Historical Architectural Review Board COA Preliminary Review Sheet

HDC-2025-00046

Address: 1022 Chew Street

Proposal: Construct a third-floor dormer addition at the rear of the house

Proposed Dormer Addition (Applicant)

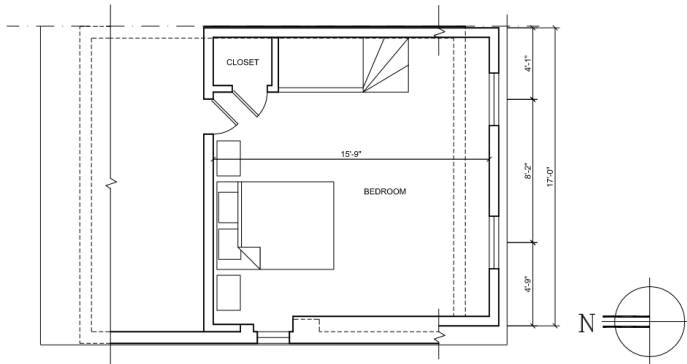
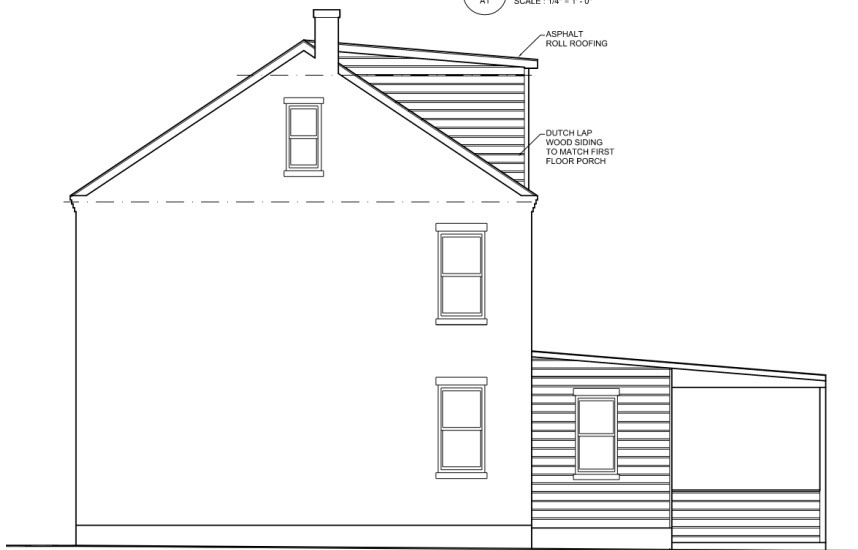
- A dormer addition at the rear of the building is an appropriate location. There would be some visibility from Howard Street, and from Zieglers Court at the rear. It is not clear if the dormer would be completely obscured from view along Chew Street, or if it would be only minimally visible.

- The proposed dormer does occupy a majority of the rear roof. It would be helpful to understand if it is possible to reduce the overall width and/or length of the dormer.

- The proposal indicates two windows in the dormer. The 1/1 configuration is in keeping with the other windows on the building. More information would be helpful, including the materiality of the window, and overall dimensions. It appears that the windows are larger than the existing second floor windows, which does not follow the typical proportion of windows in dormers, which is that dormer windows are smaller than primary windows.

- The proposed siding is wood Dutch lap siding to match the rear first floor area. Wood lap siding is appropriate per the Guidelines. Per the Guidelines, all wood elements are to be painted.

- Gutters and downspouts were not included in the application materials. More information would be helpful to understand if these elements are intended to be included, and if so, the materials and profiles of those items.

- The dormer footprint is reduced in size in width and/or depth, so as to occupy less of the rear roof slope and be in a more similar proportion to other original dormers in the area.
- Window materiality is in keeping with the Guidelines.
- All wood elements are painted.
- Any proposed gutters and downspouts for the dormer are submitted for approval.

The HARB discussed that the dormer is appropriately placed on the rear roof slope. The dormer width is to the interior face of the party walls. The materiality of the windows could be wood, aluminum clad wood, or fiberglass. The gutter on the dormer would be a half round with a round downspout.

Mr. Hammond noted agreement with recommended staff conditions but removing the first condition about the reducing the size of the dormer. The board was in agreement that the size of the dormer is appropriate, given the stair location in the interior and nearby building configurations.

- Window materiality is in keeping with the Guidelines; wood, aluminum clad wood, or fiberglass.
- All wood elements are field or factory painted.
- Any proposed gutters and downspouts for the dormer are half round gutters and round downspouts, in keeping with the Guidelines, subject to staff approval.
